E8357A-02F

S E R V I C E N O T E

E8357A PNA Series RF Network Analyzers

Serial Numbers: 00000000 thru 46999999

Figure 1

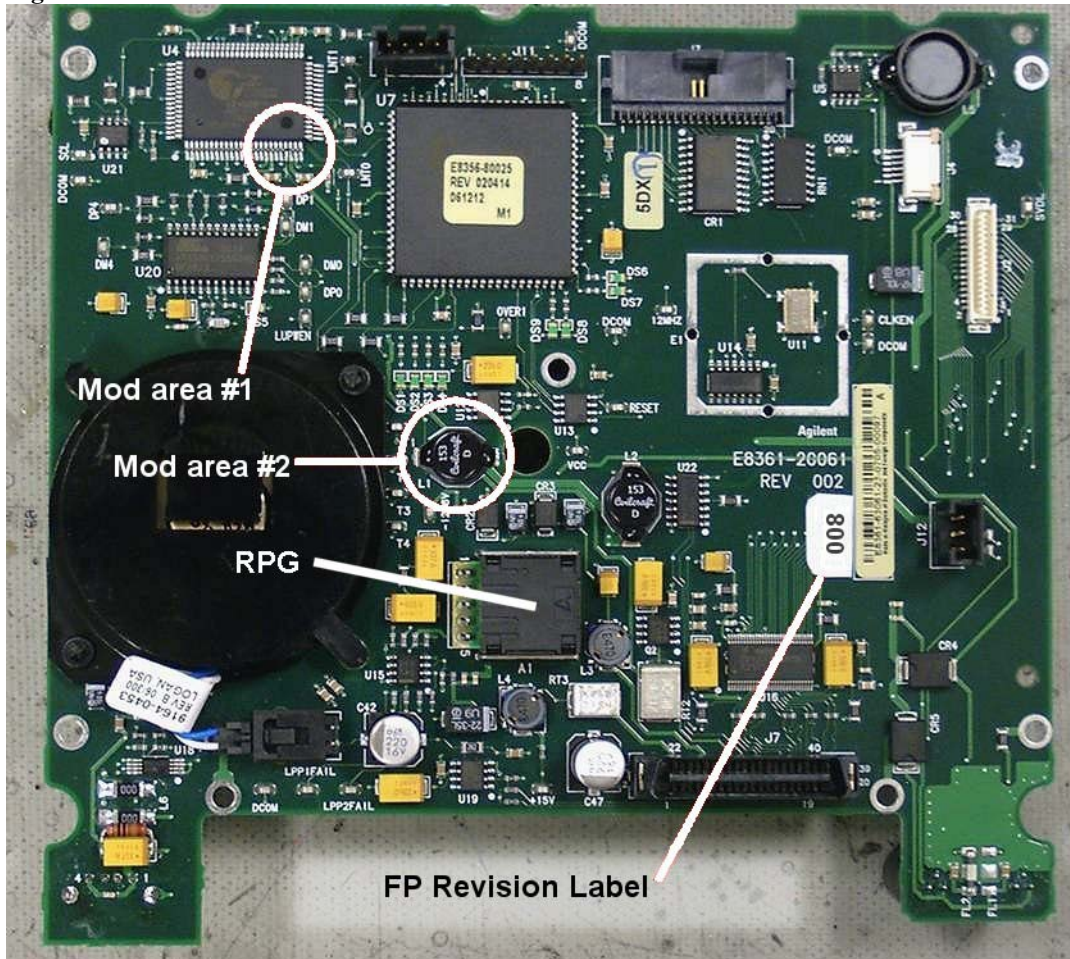
Refer to Figure 1 for the two modification areas to be addressed. Note that while this picture happens to show the FPI board completely removed from the front frame assembly, this is not necessary to perform the required modifications.

- Modification #1 consists of shorting two pins of U4 together with a small amount of solder.
- Modification #2 consist of removing L1.

Figure 2

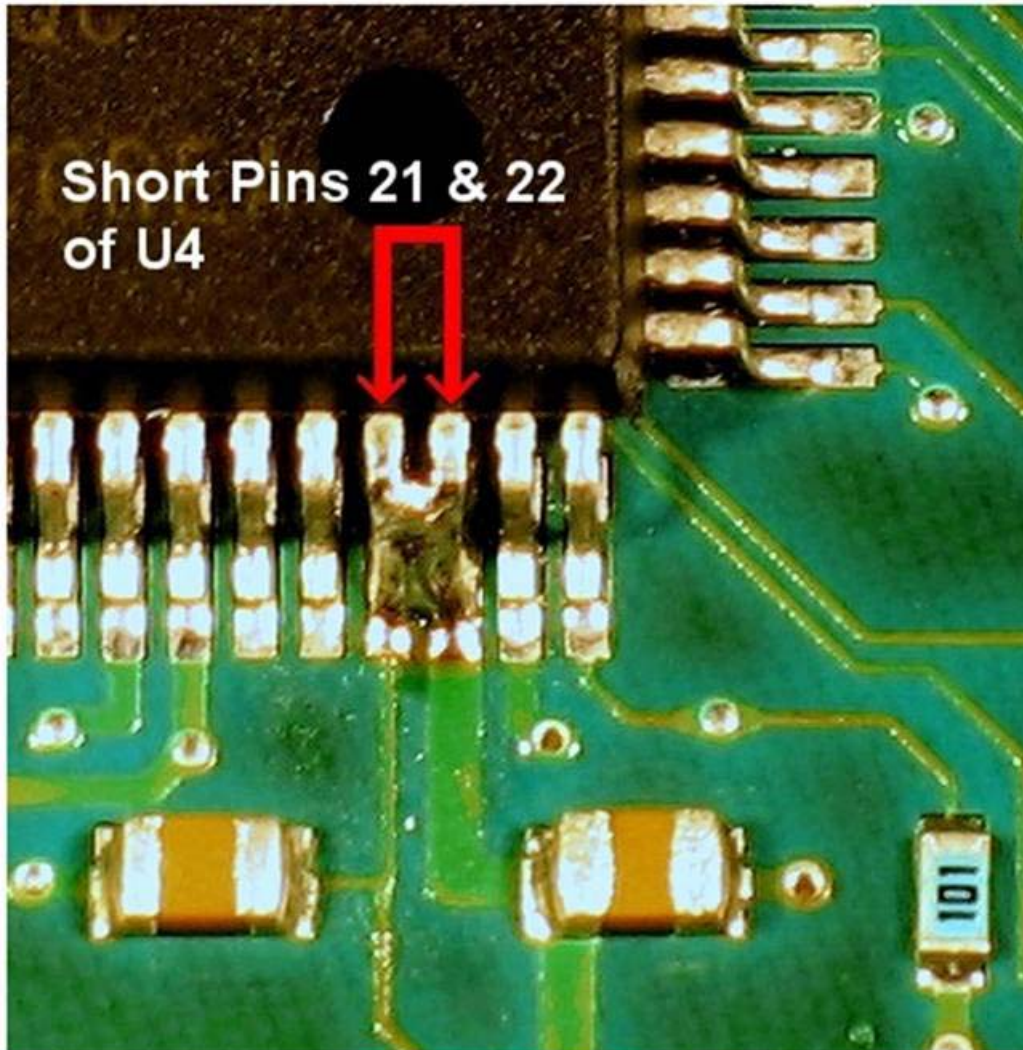
Carefully solder pins 21 and 22 together on U4. Refer to Figure 2 for the exact location. Use care so that no other pins are shorted. Use of a very fine tip soldering iron is recommended and a large work-task magnifying glass is very helpful.
